Re: 22 Marmora Street, Freshwater

I refer to your letter dated 25 May 2021 in regards to DA2021/0624.

Image: Tree 2 from the Arborist's overlay

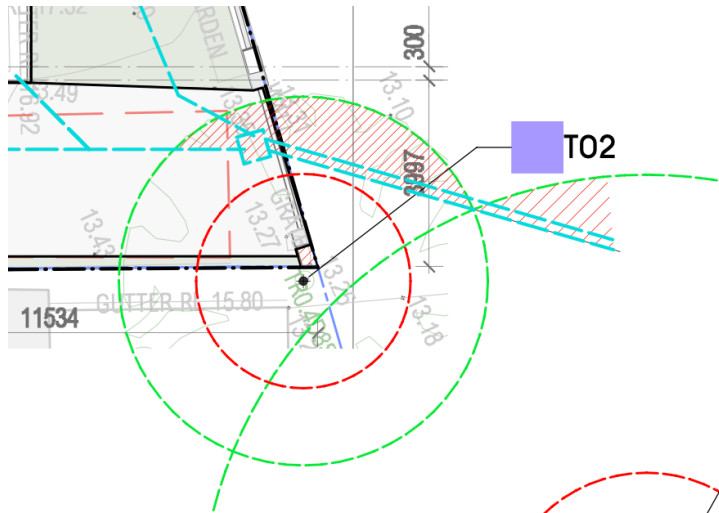
Tree 2

It is noted that concern has been raised in relation to tree 2. Given a driveway currently exists in place of the structural root zone, root mapping could not currently take place without removal of the driveway. We would propose that it is conditioned that root mapping be undertaken by a Level 5 arborist once access is available and that they are required to sign off on this component prior to any stormwater works taking place. If root mapping revealed a change to the stormwater was required the location would be revised to suit. The hydraulic engineer has noted on his plans that adjustments on site may be required.

Image: Tree 14 from the Arborist's overlay

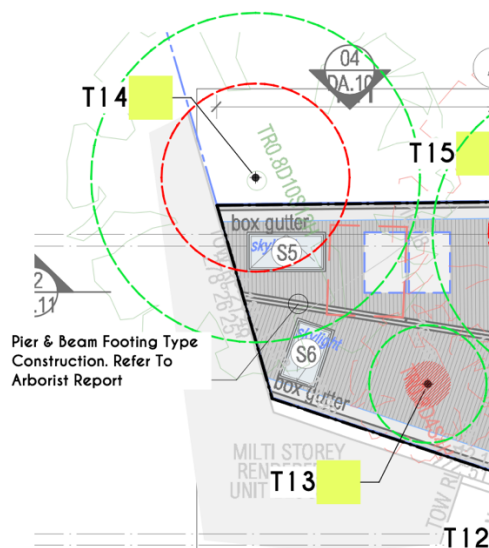
Tree 14

We confirm that as per the arborist's report the area around the tree will be hand dug and will use tree sensitive construction types whether it be pier and beams or sections of cantilever. As structural engineering plans are not required within the DA, and constitute the CC works, we would request that a condition be included that requires tree root mapping prior to works commencing and that the structural engineer's plans, prior to being accepted to form part of the CC, be signed off by the Level 5 arborist.
